Re: Ex Parte Notification in CC Docket No. 99-168 -- Service Rules for
the 746-764 and 776-794 MHz Bands, and Revisions to Part 27 of the
Commission's Rules

U S WEST WIRELESS, LLC EX PARTE PRESENTATION DECEMBER 21, 1999

PRELIMINARY ANALYSIS OF MOTOROLA PROPOSAL

Figure 1. The spurious power radiated into a 6.25-kHz channel bandwidth plotted as a function of the offset from the band edge for both a 10-W base station and a 0.2-W mobile station.

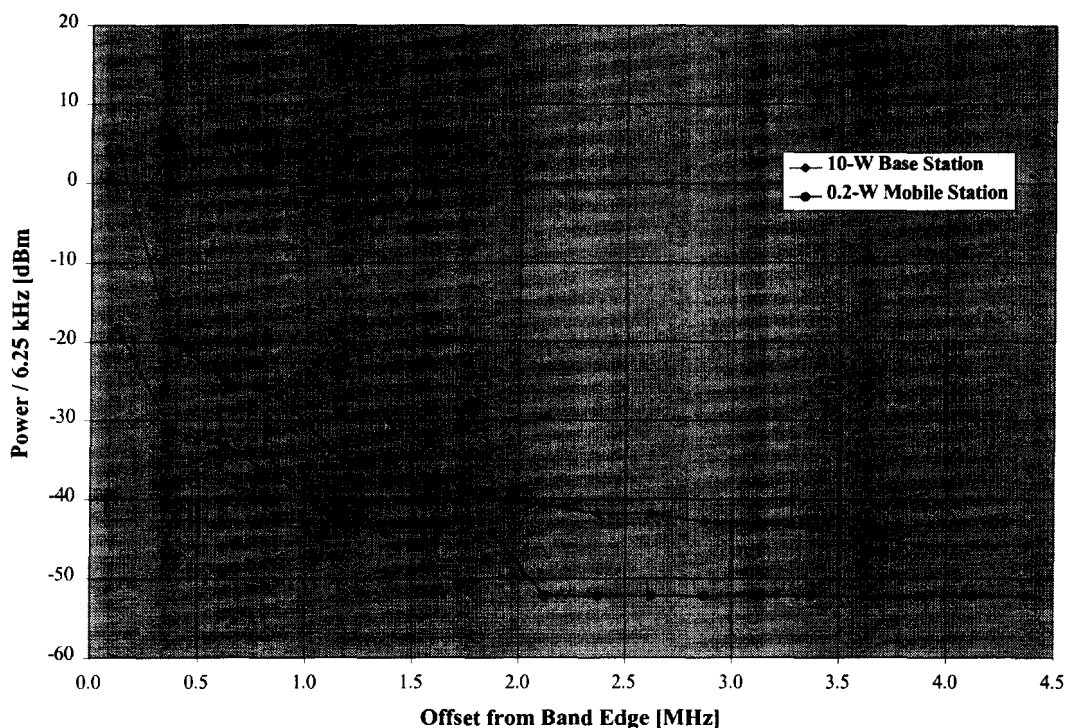
The first and most important result is shown in Figure 1. In this plot, the power radiated in a 6.25-kHz bandwidth is plotted as a function of the offset from the band edge as defined above. Typical plots are shown for both a 10-W base station and a 0.2-W mobile station.

If such equipment were placed at the edge of the commercial radio spectrum next to one of the 1.5-MHz guard bands, it is seen from the plot that the spurious emissions observed in a 6.25-kHz bandwidth would be -39 dBm and -44 dBm for the base station and mobile station, respectively. Such results indicate that spectral requirements that are more stringent than on the order of -40 dBm at the edge of the public-safety band could significantly reduce the utility of the commercial radio spectrum. Based on these plots, a -50-dBm specification would require over 2 MHz of guard band, and would limit the base-station transmit power to a level on the order of 1 W, even if the out-of-band emissions scaled directly with the channel power.
